(2) Auster 3, 4 and 5 Variants 'J' and 'D' Series and Taylorcraft Plus 'C' and 'D' Aircraft

UK National Airworthiness Directives previously published in CAP 476 – Mandatory Aircraft Modifications and Inspections Summary

CAAAD No: 2487 PRE 80

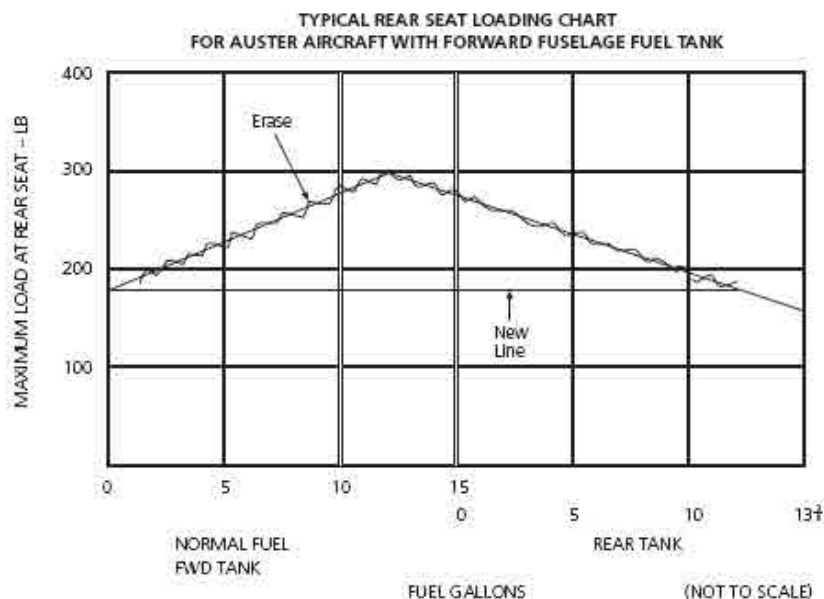
Description: Rear seat loading limitations amendment.

Applicable to Auster Models Mk4, Mk5, Mk5C, Mk5D, J1, J1B, J1N, J1S, J5, J5B, J5F, J5G, J5H, J5K, J5L, J5P, J5Q, J5R, J5V, D5 and D6 which are fitted with a forward fuselage fuel tank. Compliance is required prior to the next flight on which it is intended to carry passengers on the rear bench seat, but in any case not later than 30 September 1976. Amend the loading limitation chart which is displayed in a plastic holder on the rear cabin bulkhead, as follows:

(1) Draw a line, parallel to the base line of the chart, from the rear seat load at zero fuel, i.e. the intersection of the loading limitation line with the left-hand vertical axis of the chart, and continue this horizontal line to intersect with the right-hand slope of the loading limitation line.

(2) Erase all that part of the original loading limitation line, which lies above the new line (drawn in accordance with 1).

NOTE: The following sketch illustrates an amended loading chart. If the existing loading chart should differ significantly from this illustration, advice must be obtained from the CAA prior to amendment. This Directive hereby authorises the Operator to make an entry in the aircraft Log Book, quoting the AD number, and this entry must be made when the loading chart has been amended in accordance with these instructions.
